CITY OF MENIFEE
PROJECT "HOT SHEET"
PUBLIC WORKS/ENGINEERING DEPARTMENT

***Bundy Canyon Development
Lot 2 of PM 13249***

(APNs 384060002, 384060007, 384060009)

October 9, 2024

ASSESSOR'S MAP BR384 P.06
Riverside County, Calif.

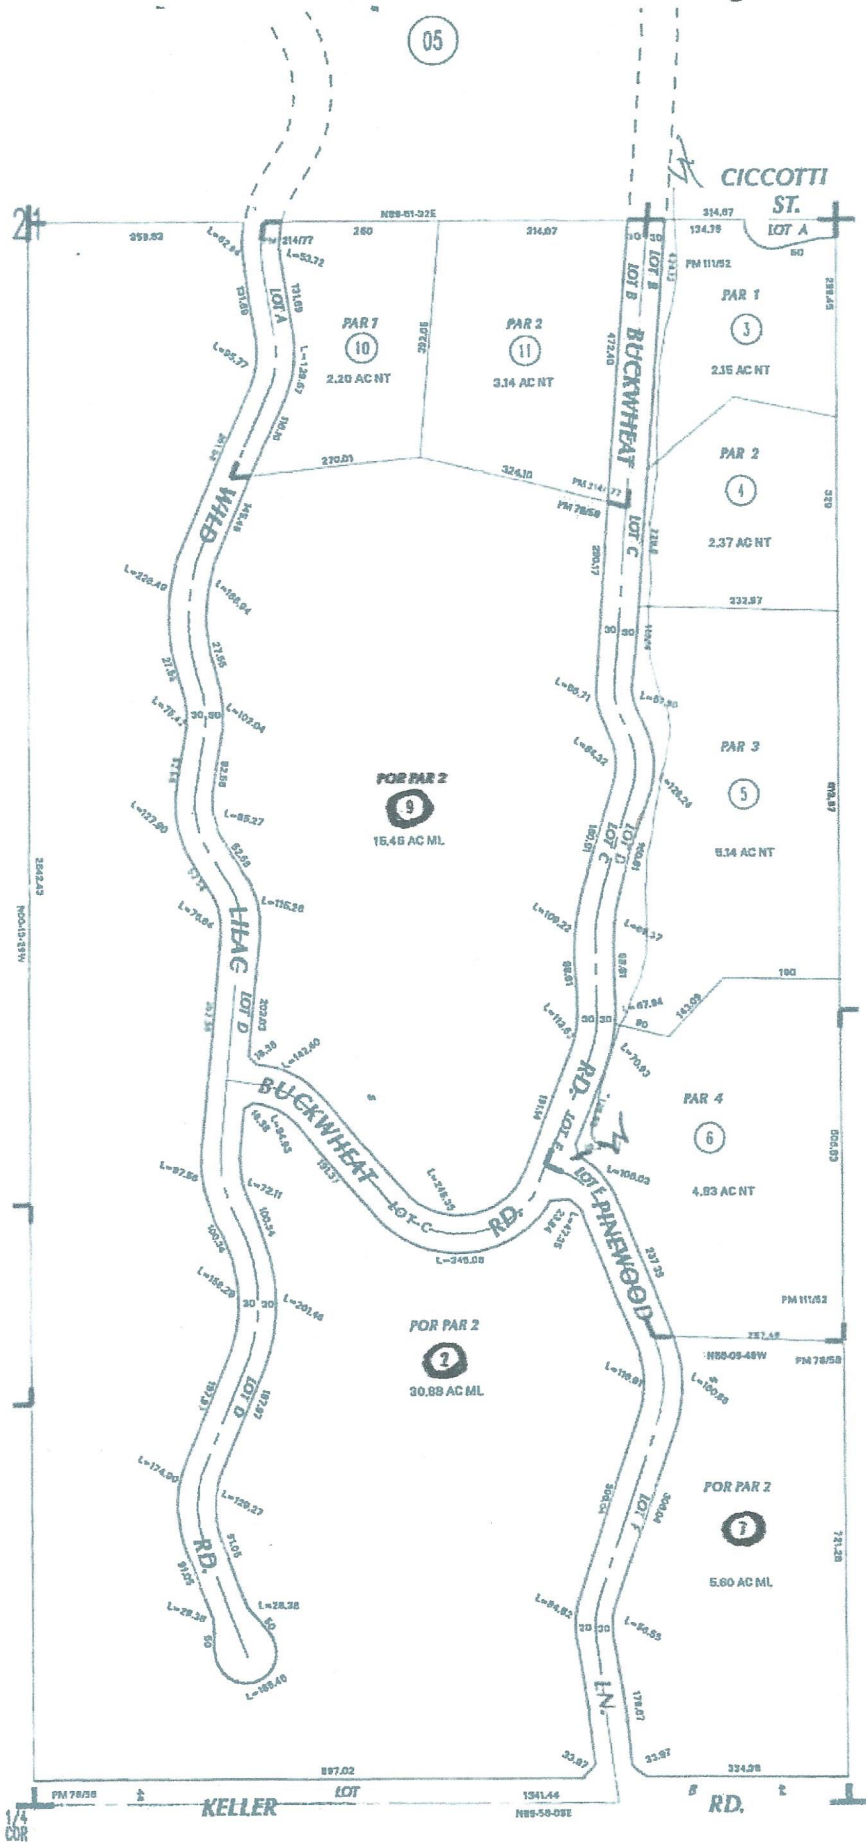
2. There has been confusion with "parcels" vs. "APN's". APN is an acronym for "Assessors Parcel Number", and are only "official" for the purposes of tax assessment, APNs **DO NOT** define legal lots. In fact, every page of an APN map stated that it can only be used for tax purpose only. The attached print shows the legal boundary of the existing property. Lot 2 is currently owned by, "BUNDY CANON DEV CO"
